From: Alison Kimble <alison.m.kimble@gmail.com>
Sent: Monday, February 10, 2020 6:45 PM
To: Daniel Martinez
Subject: Re: Spar Pump Station Questions

I live in Westridge South, and I was wondering about the status of the Spar Pump Station project (Project Number: PRJ15-00036).

Subject: Spar Pump Station Public Comment

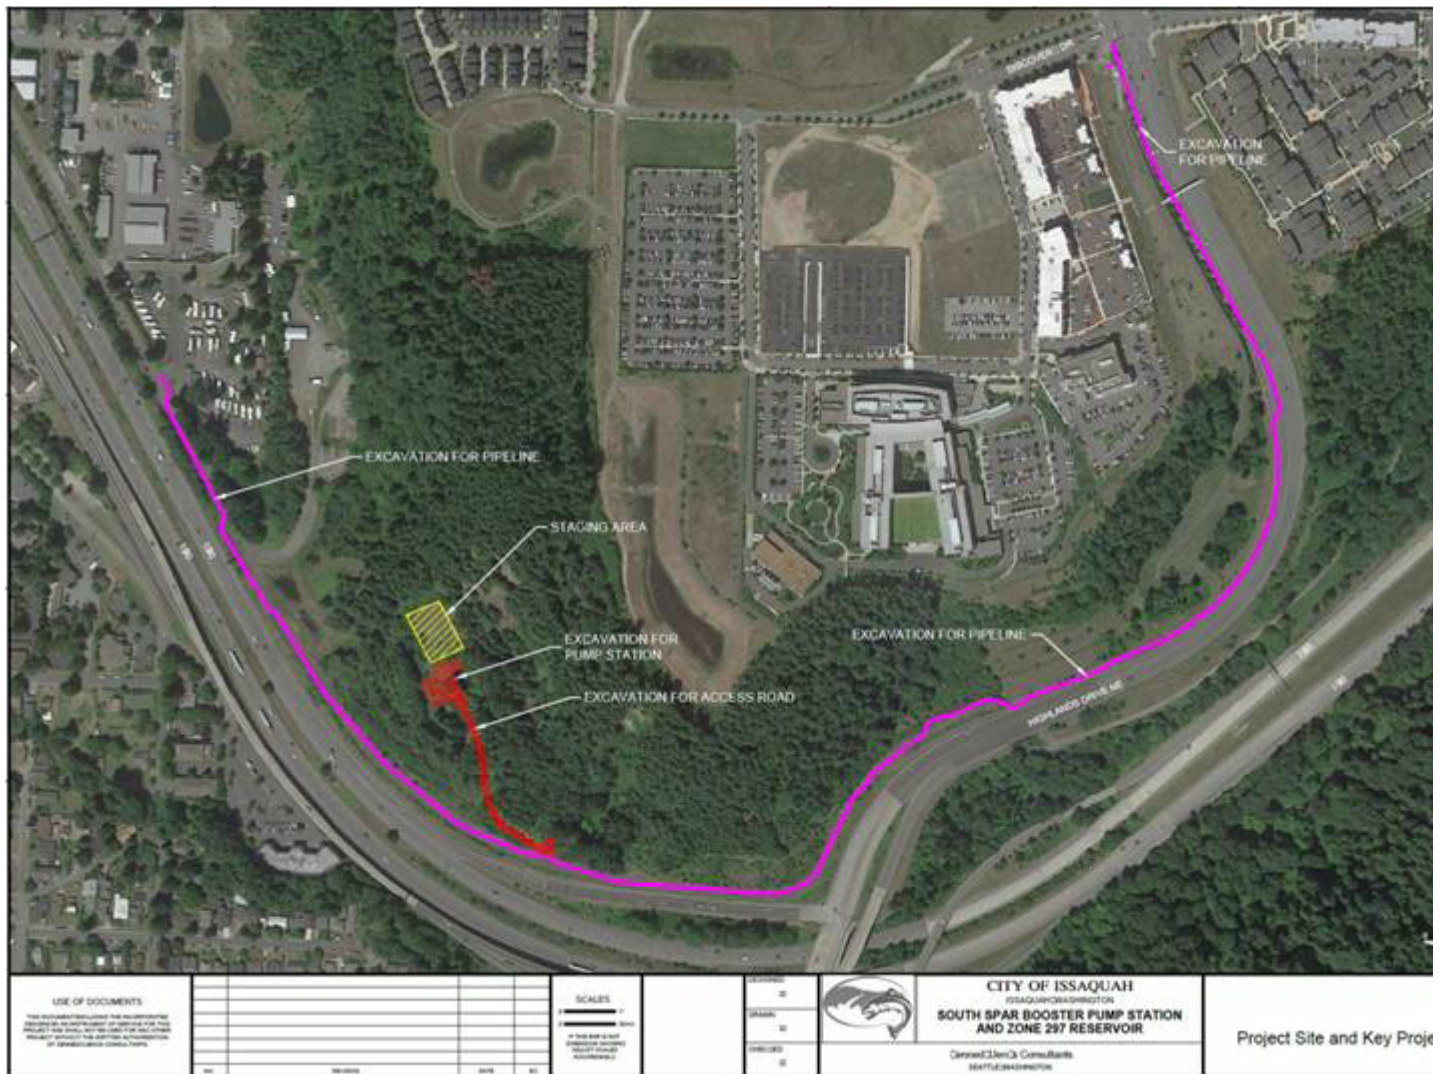
- Will there be a barrier of trees between the houses in Westridge South, and the station?
- Will the trees/barrier be protected as a green belt (obviously this would be very much preferred), or will the remainder of the land be open to other development?

The short answer to your question about a “barrier of trees” is yes, there will be a barrier of trees. The image below demonstrates the area needed for the access road and the pump station. The only trees proposed for removal are those within the approximate area shown in red. All other healthy trees are proposed to remain.

The site is zoned Community Facilities (CF) and is owned by the City. This a phased project; meaning that the booster pump station is being considered now, while a reservoir is planned for a future date (5-7 years). The location of the reservoir is approximately the area shown in yellow. Beyond this project, I am unaware of any planned development for the site.
